Jemalong Solar Farm MOD 2

*State Significant
Development
Modification Assessment
(SSD 8803 MOD 2)*

September 2019

Figure 2 | Approved and Proposed development footprint comparison

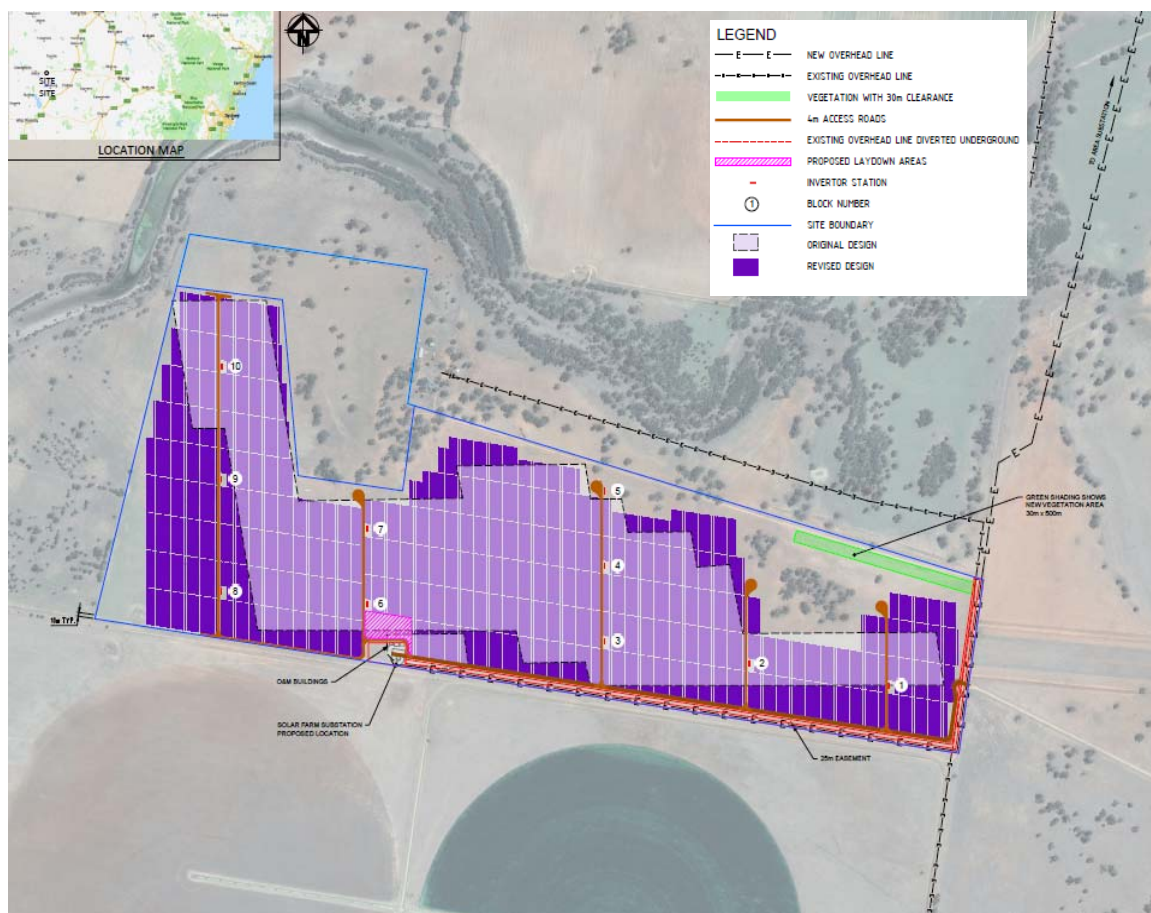
Genex is seeking to further modify the development consent (SSD 8803) for the Jemalong Solar Farm. The modification is described in detail in the Modification Report (see **Appendix B**) and a comparison of the proposed development footprint with the approved development footprint is shown in **Figure 2**.

The proposed additional area of solar arrays would increase the approved 74 ha development footprint by 38 ha (an increase of 51%). The revised development footprint would be 112 ha within the existing 165 ha project site.

The proposed expansion to the development footprint is the result of the detailed design process of the solar array and a review of constructability to achieve 50 MW electricity generation capacity undertaken by Genex since acquiring the project. Detailed design has resulted in an increase in spacing between the rows of solar panels and changes to the internal access tracks.

The expanded development footprint would retain the minimum 10 m defendable space around the perimeter of the solar array within the revised development footprint as required by the consent conditions to treat the development as an asset protection zone (APZ).
